UNITED STATES PATENT AND TRADEMARK OFFICE

10/710,253

Office Action Summary

DETAILED ACTION

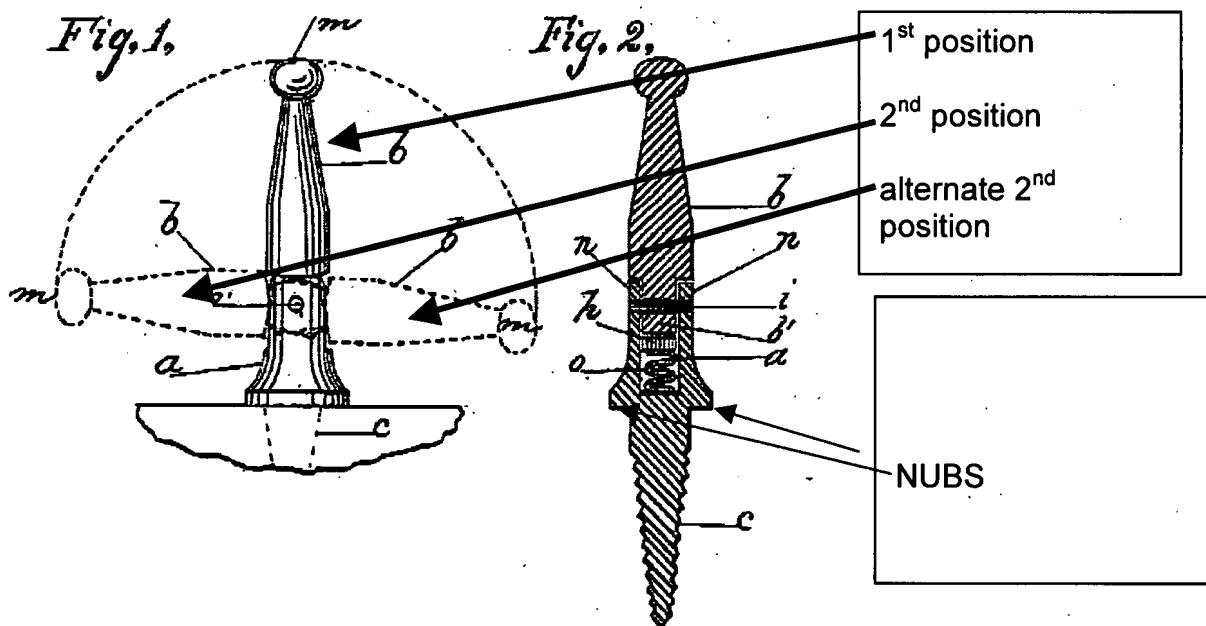
5. Claims 12-13,18,24,26,30,31 are rejected under 35 U.S.C. 102(b) as being anticipated by Votaw, USP 370028.

Re claims 12 and 30: Shaft is "a", locking member is "b". First (solid line version of "b" in Fig 1) and second (dotted line version of "b" in Fig 1 above) positions are as indicated in Fig 1 and described above.

Spring "o" and plate "h" serve as retention means for either the 1st or 2nd position.

Note that the slot is considered the lengthwise recess -- "that portion below the base of the jaws is bored out or recessed lengthwise to receive a spring "o"..." The at least one cut out portion on an outer surface and disposed along a slot is the center cut-out portion between jaws "n", which is sized to receive locking member b in seating engagement and retain the locking member in the second (no removal, dotted lines of b) position.

FURTHER RE claim 30: The locking member extends laterally from only one side of the shaft per Fig 1. Note however, it can extend in either of 2 locking positions.

Re claim 13: "C" is considered the angled end portion located at second end of shaft member-- Fig 2.

Re claim 18: Nubs are labeled in Fig 2 above.

Re claim 24: 1st and 2nd cut out portions 90 degrees apart are considered the openings between the jaws n. Note that the center cut out portion between jaws can be considered 3 cut out portions -- a portion on the "top plane" through which locking member extends when in the 1st position, and a cut out between the jaws on the left side through which locking member extends when in the 2nd position and a portion between the jaws on the right side of the shaft through which locking member extends

when in the alternate 2nd position. These 3 cut out portions form the center cut out portion described by Votaw.

Re claims 26 and 31: The locking member b is adapted to be pulled out of engagement with the at least one cut out to allow the locking member to be rotated from the 1st to the 2nd position. Spring force will require at least some degree of pulling out to rotate the locking member from 2nd to 1st position.
